| 8802-3/802.3 REVISION REQUEST 1143 |

REQUESTED REVISION:  
STANDARD: IEEE Std 802.3-2002  
CLAUSE NUMBER: Figure 7-6  
CLAUSE TITLE: PLS Input and Data\_Valid function

Figure 7-6—PLS Input and Data\_Valid function

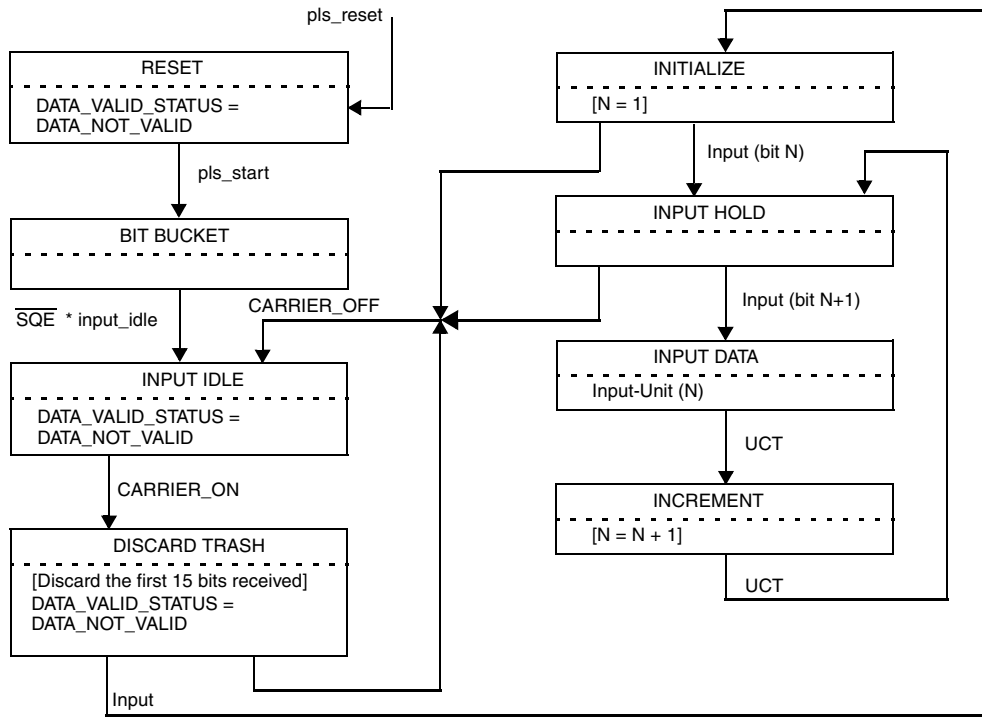
Change text from "SQE \* input\_idle" to "not SQE \* input\_idle". The not applies only to SQE.

Error when figure was converted from 1996 version.

For exit from state "BIT BUCKET" to state "INPUT IDLE", an inversion on signal SQE was dropped in edits.

Replace Figure 7-6 with the following:
